UNITED STATES PATENT AND TRADEMARK OFFICE

Office Action Summary	Application No.	Applicant(s)	
	10/696,932	MCGUCKIN ET AL.	
	Examiner	Art Unit	
	SARAH WEBB	3731

DETAILED ACTION

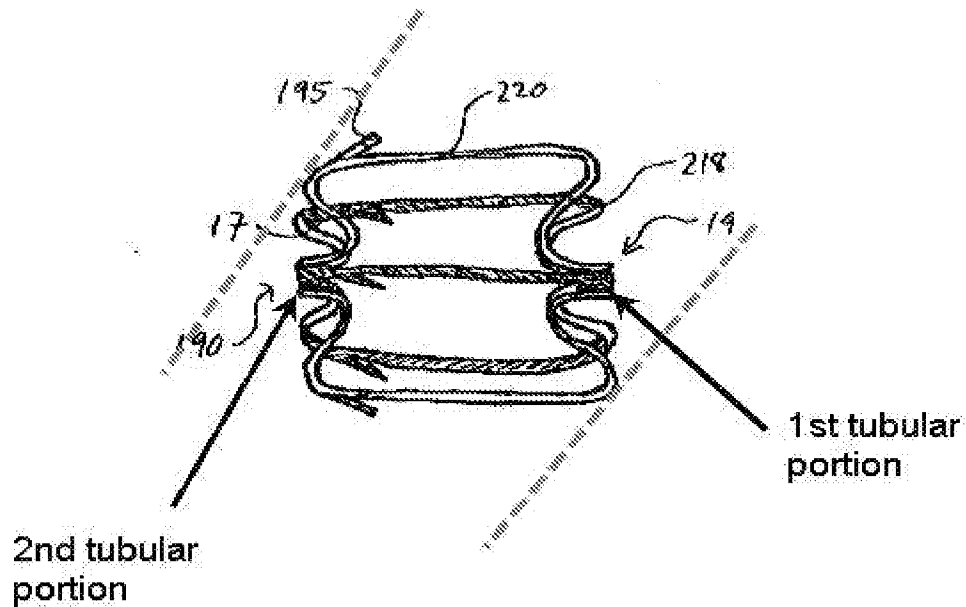
1. Applicant's arguments filed 6/22/2011 have been fully considered but they are not persuasive. Van der Burg is considered to meet the new claim requirements, as explained more thoroughly below. A tangent line is not required to extend perpendicular to the longitudinal axis, as indicated by the phantom lines drawn below. Therefore, the broad requirement is met by the Van der Burg filter.
